**Re: Request for further information on your application for Building Consent**

| <b>Application number:</b> | BC24-011274                               |
| <b>Site location:</b>      | 13 Ross Road Western Heights Rotorua 3015 |
| <b>Description:</b>        | New Relocated Dwelling                    |

**A100** Rev.B

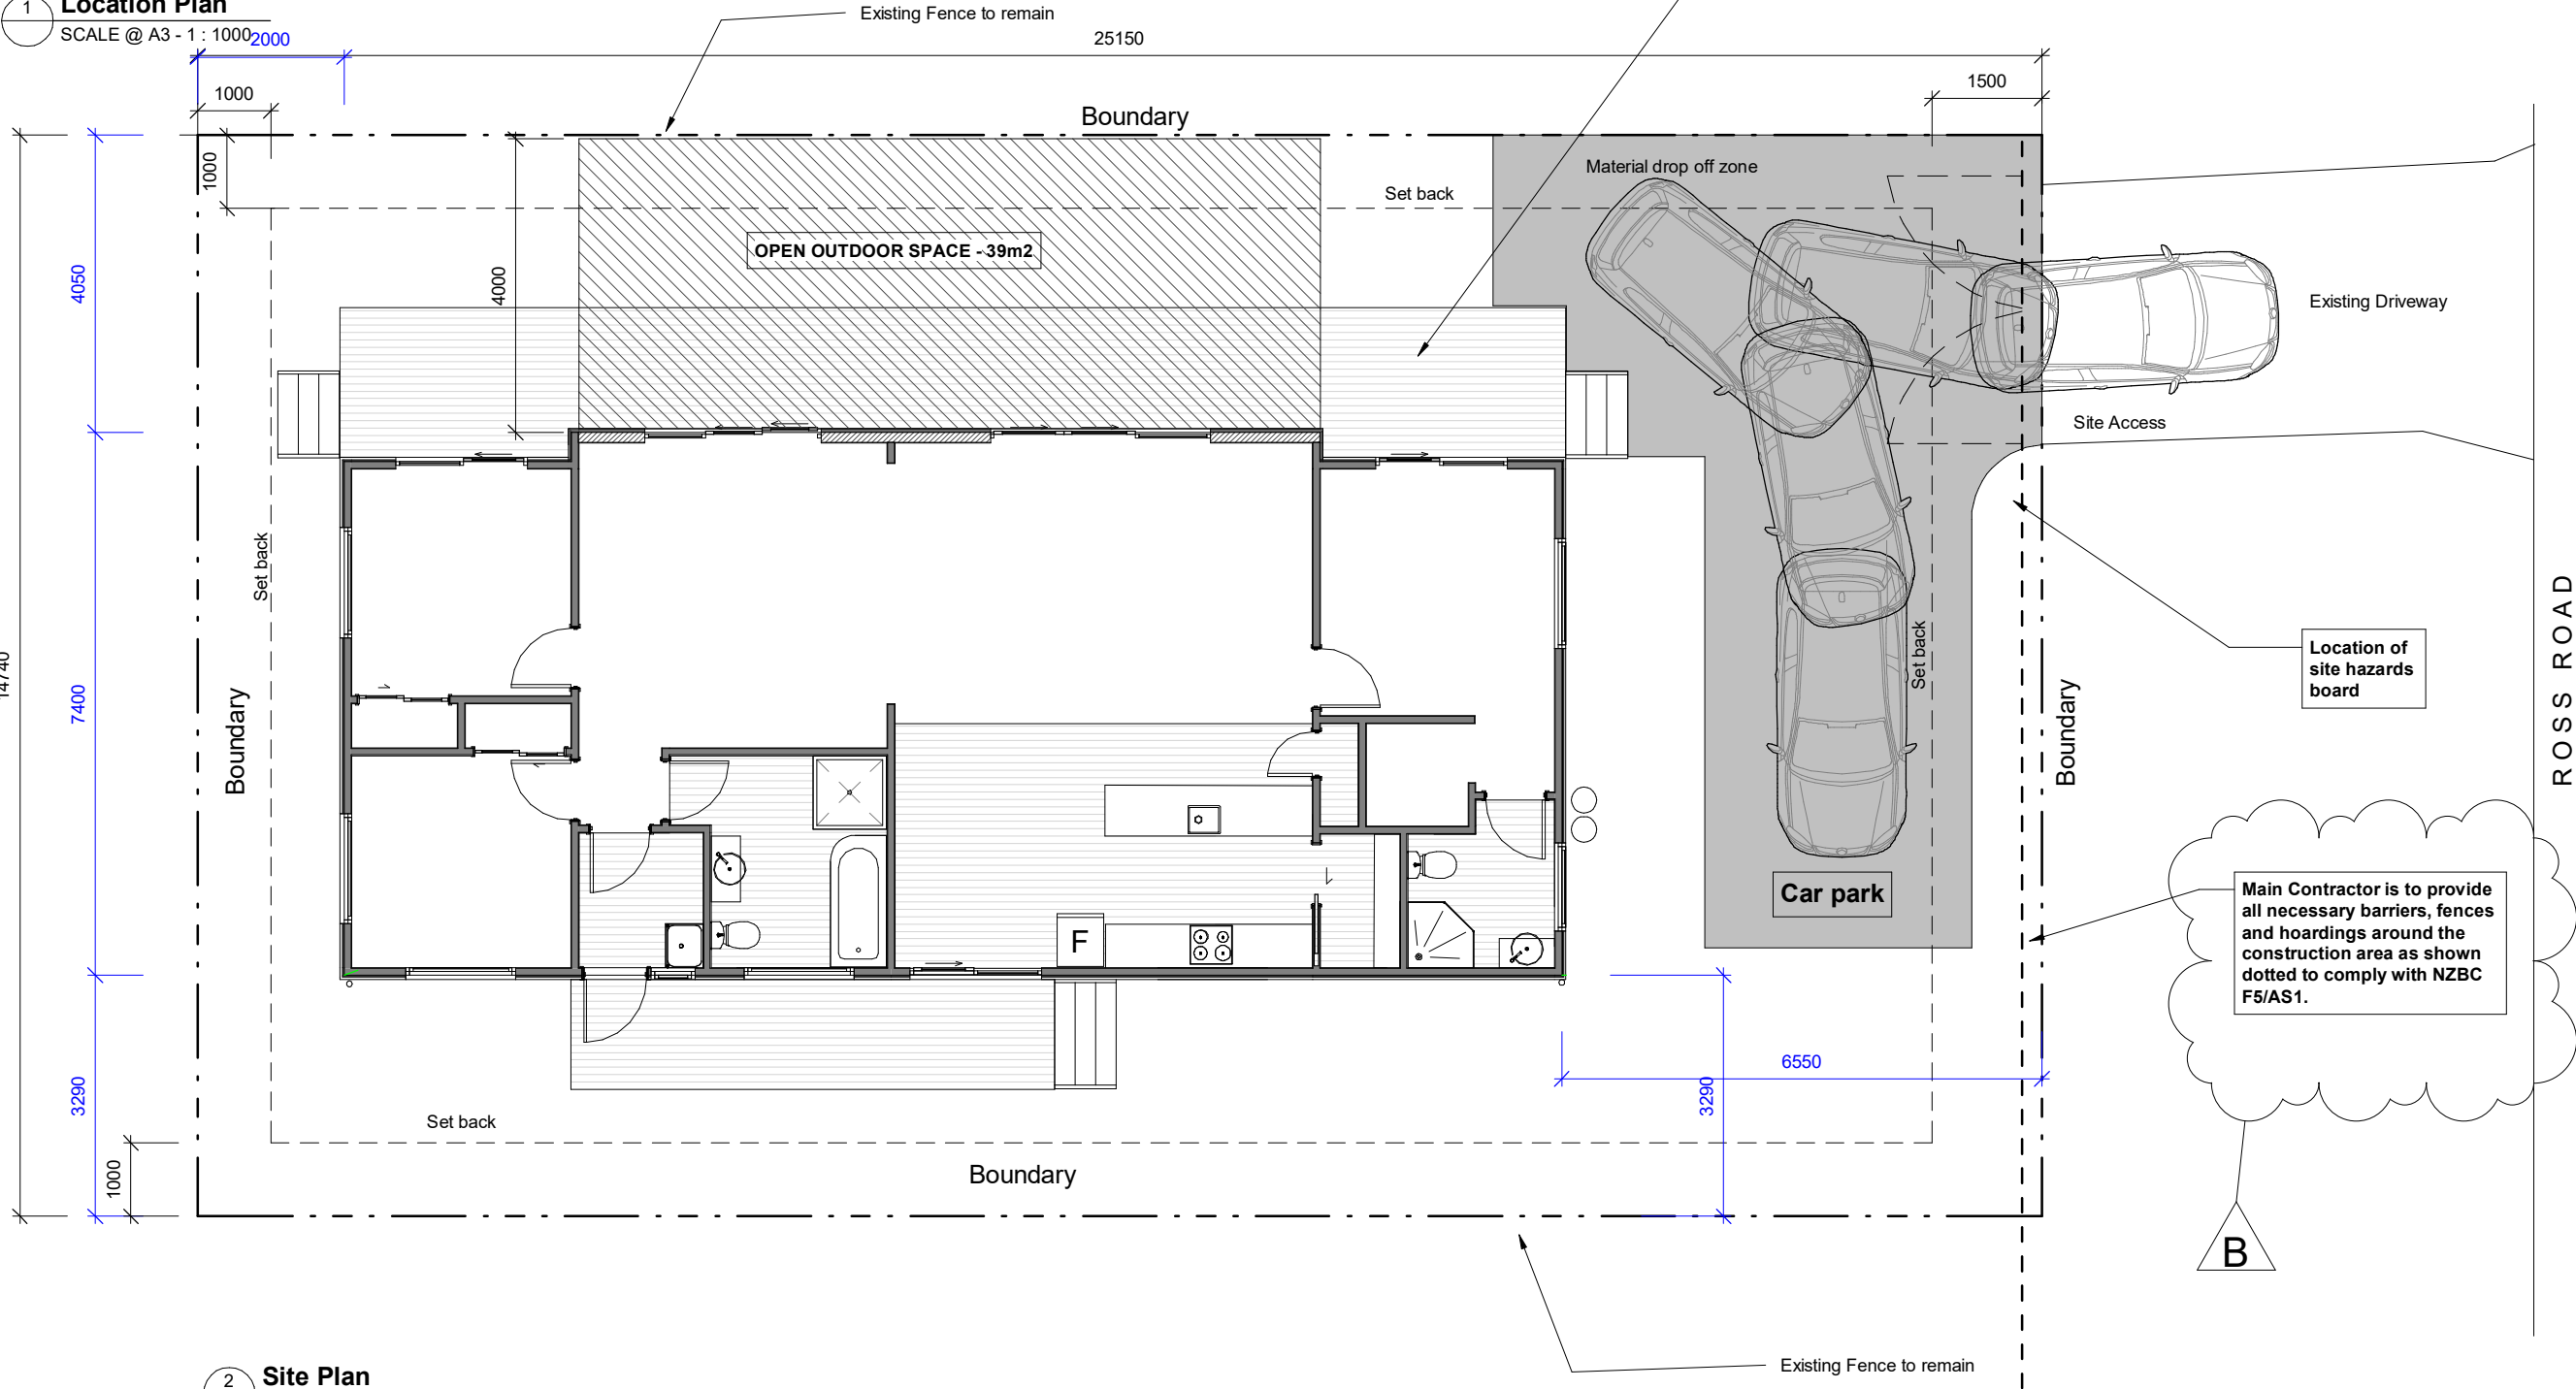
8. Is the car park area, as shown on sheet A100, going to be concreted? Demonstrate how surface water will be managed on this area in compliance with E1/AS1. [yes, sump added on A101](#)

A101 Rev.B

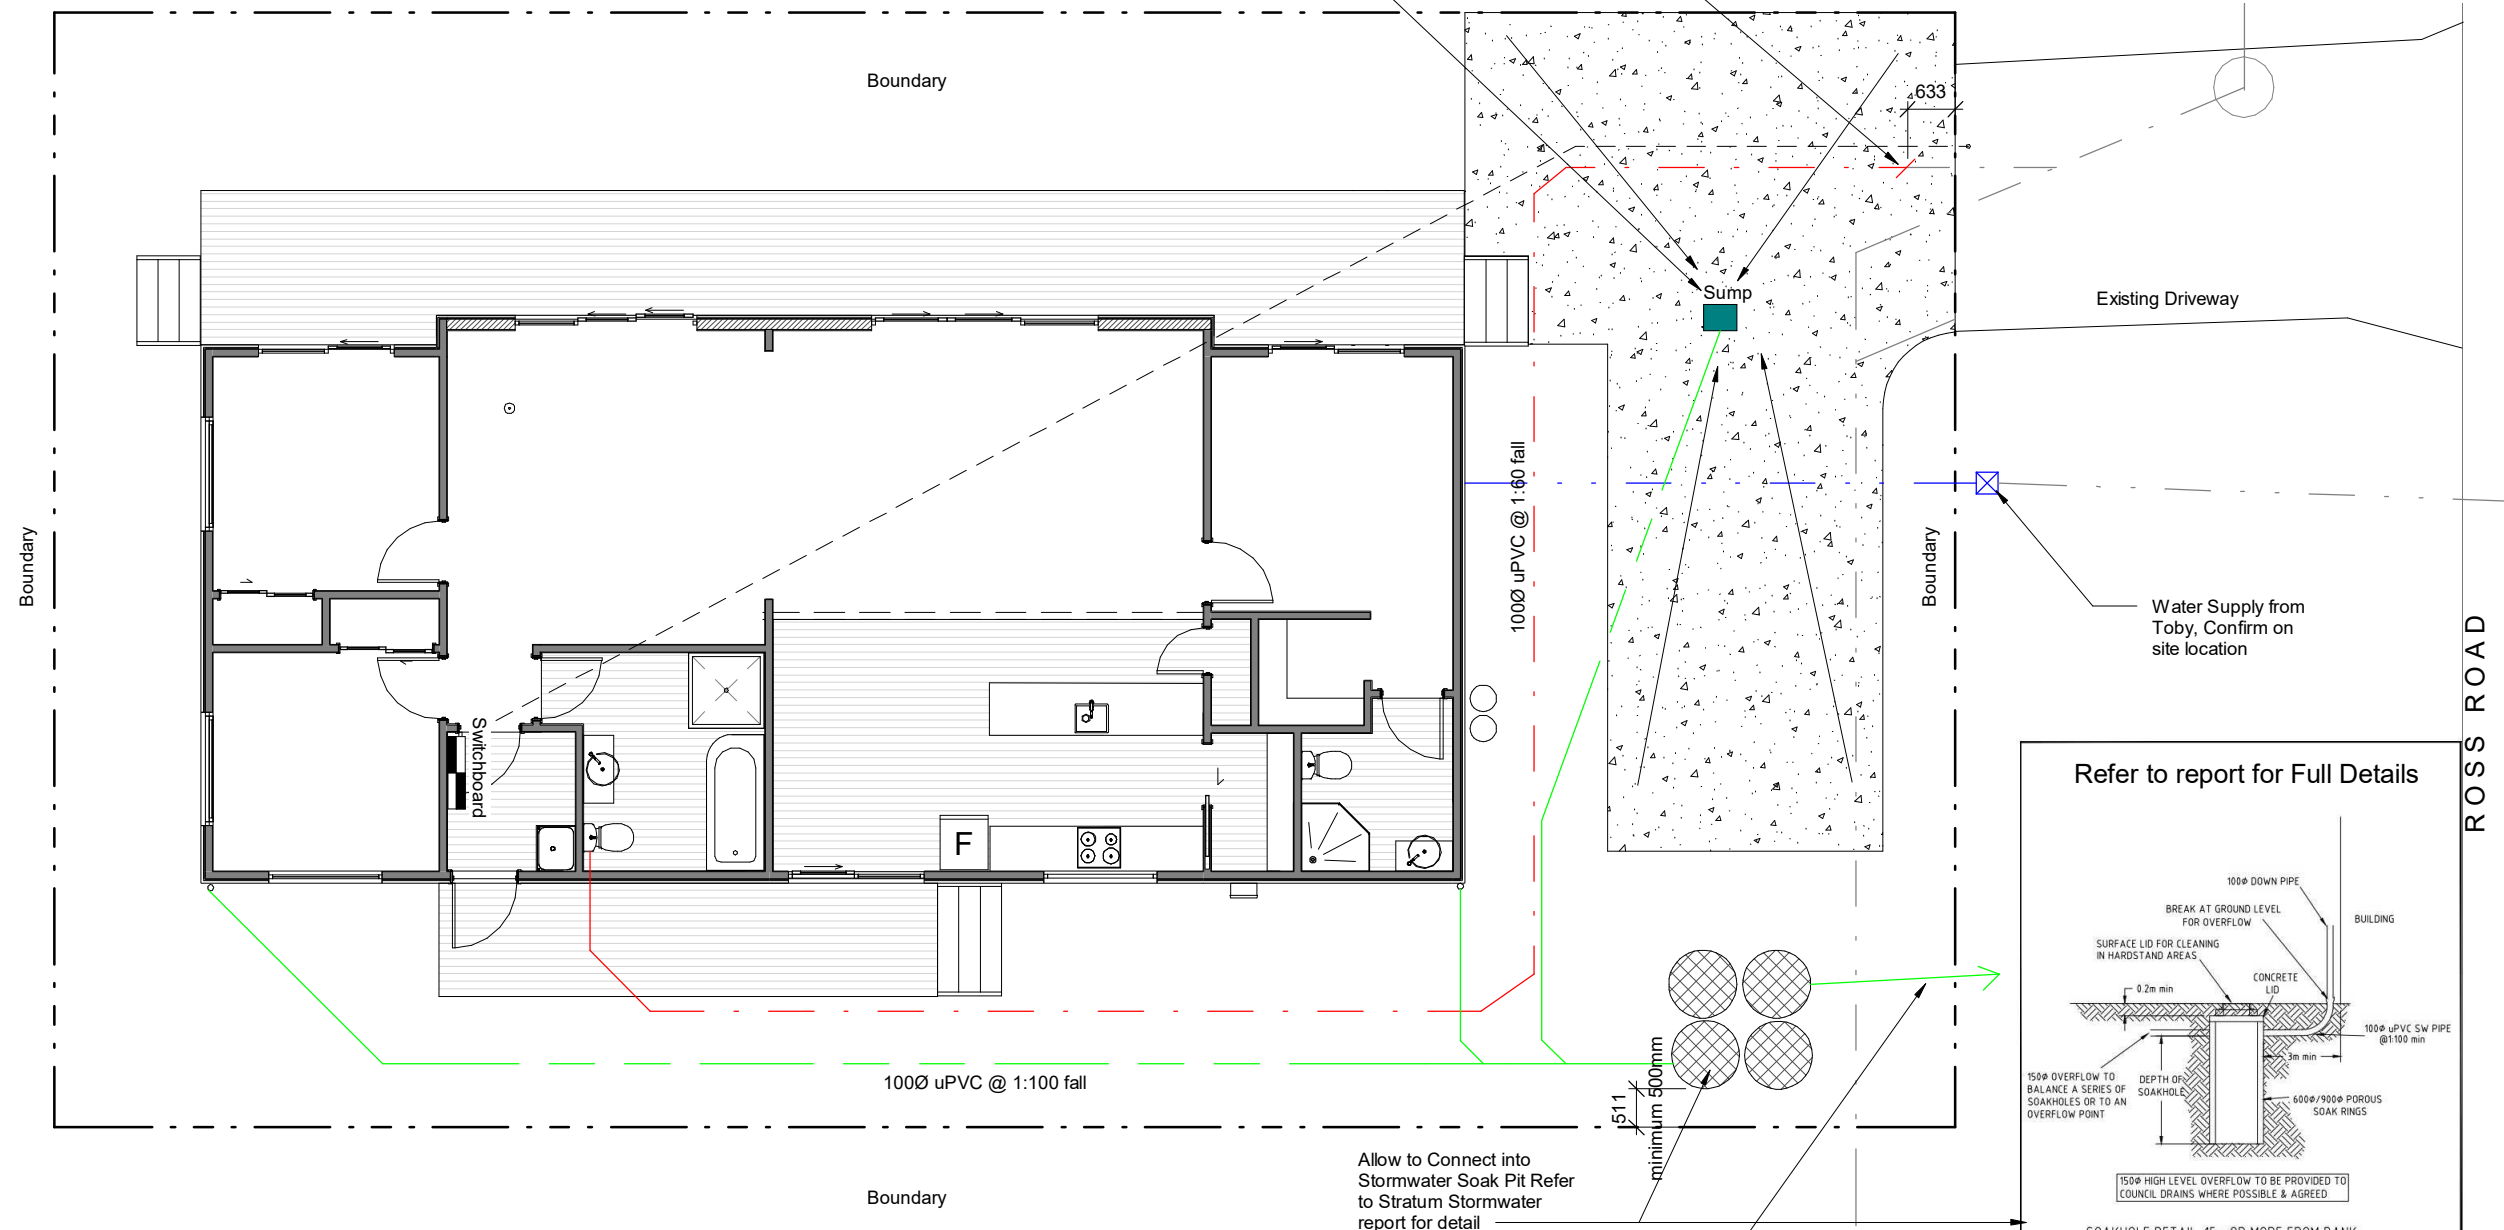
2. The plans show a stormwater connection, the stormwater network has not been designed for house connections and there is a Consent Notice registered on the title requiring stormwater to be directed to on-site soakage, updated stormwater plans required.  
[Updated attached](#)

9. Demonstrate compliance with NZBC F5. [Notes added on A101](#)

1 Proposed Subfloor Plan  
SCALE @ A3 - 1 : 100

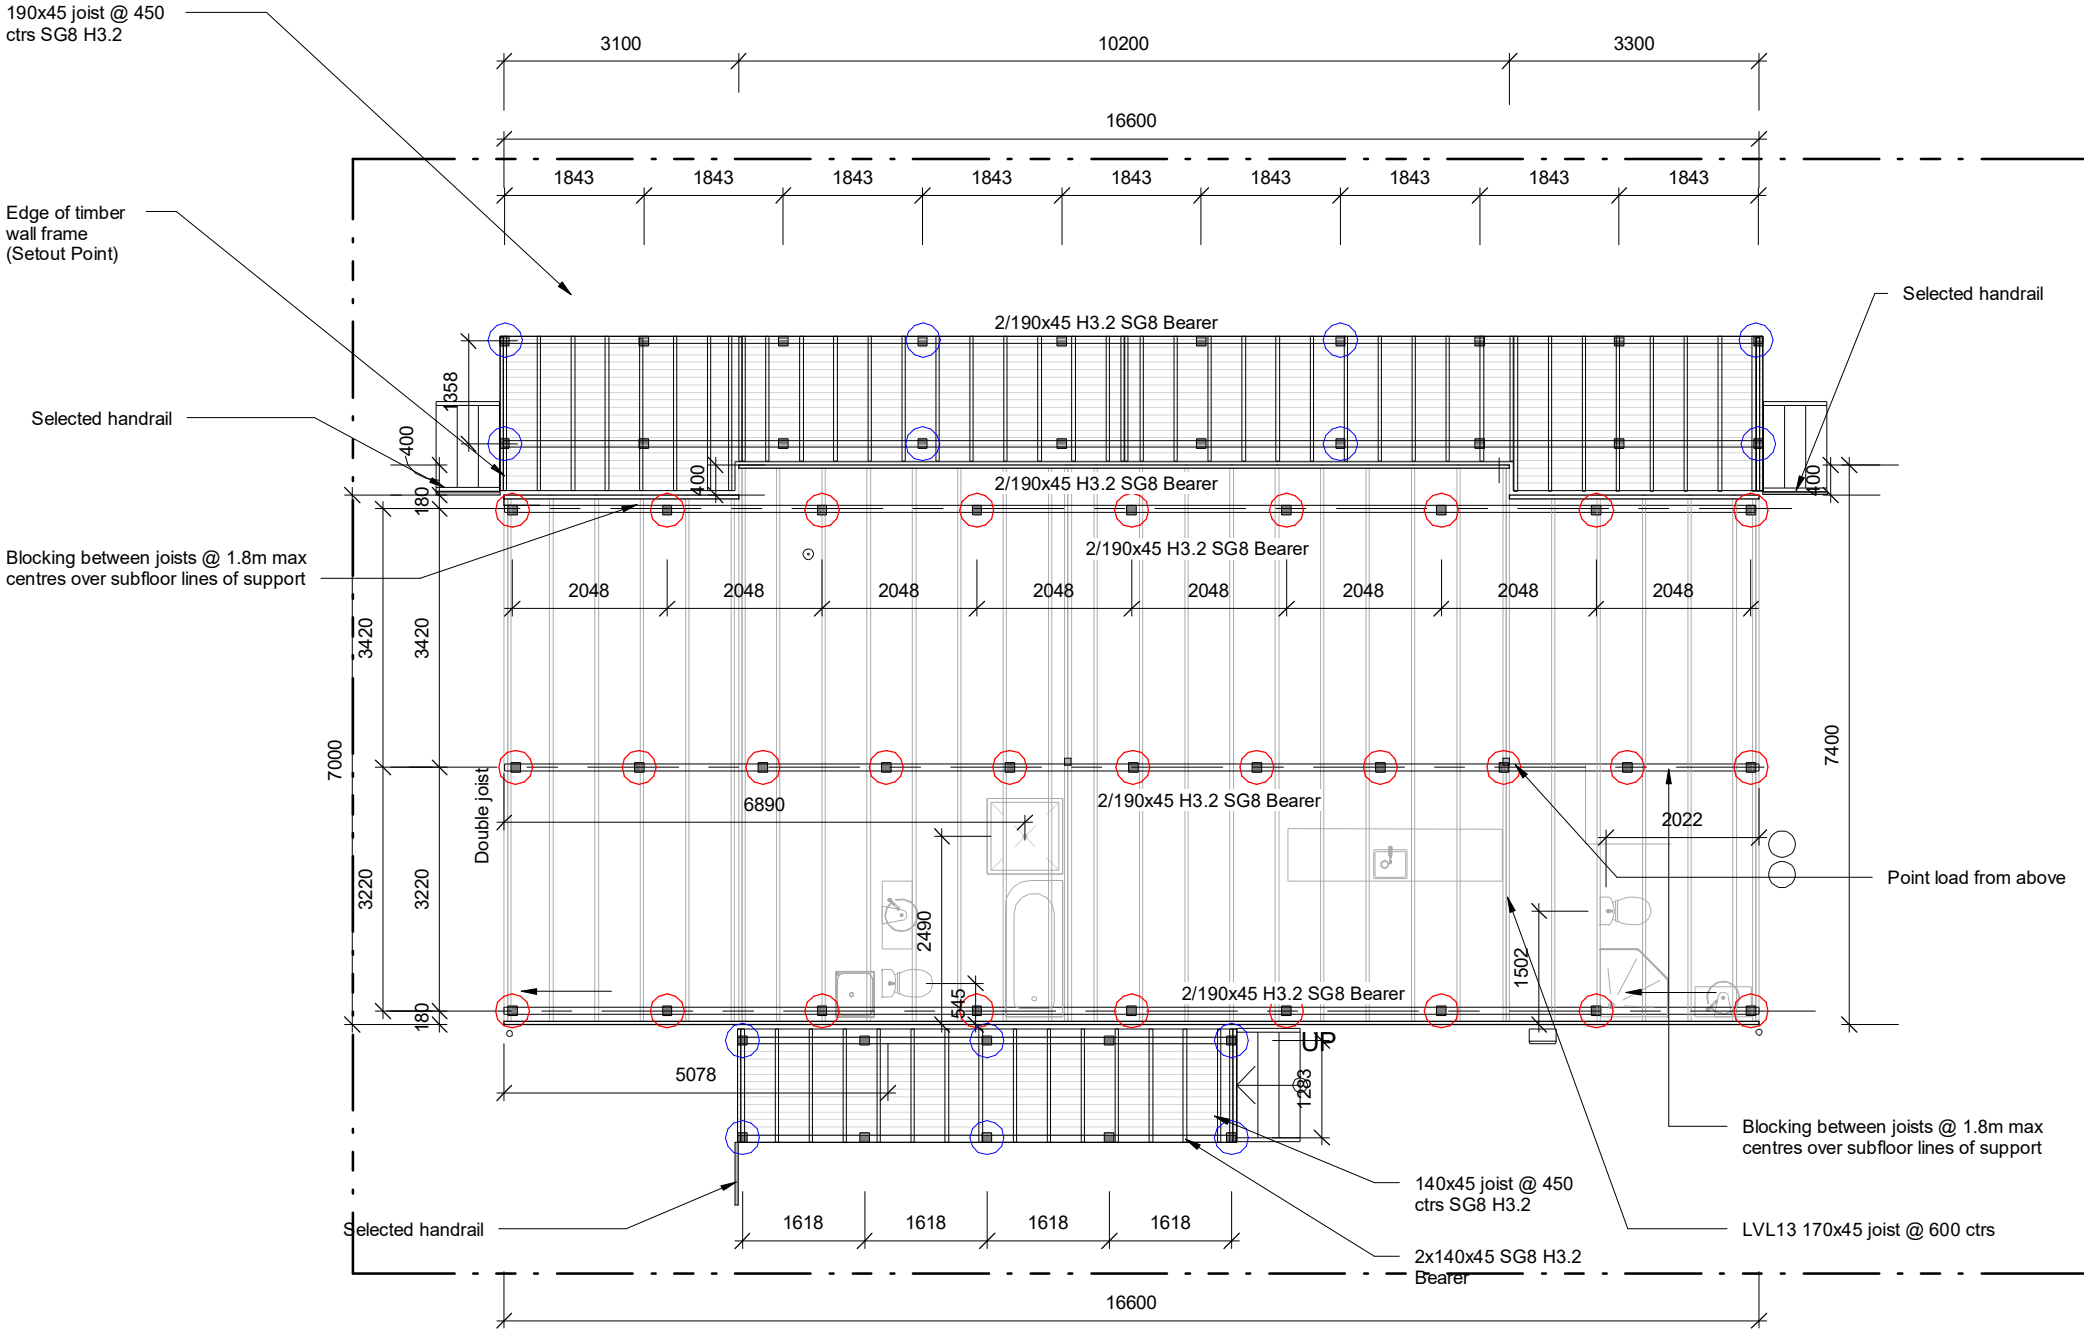
4. EQ zone on plans is Zone 1. Rotorua is Zone 2, please amend this. [now updated](#)

Wind Zone: **Low**  
Earthquake Zone: **2**  
Durability Zone: **B**
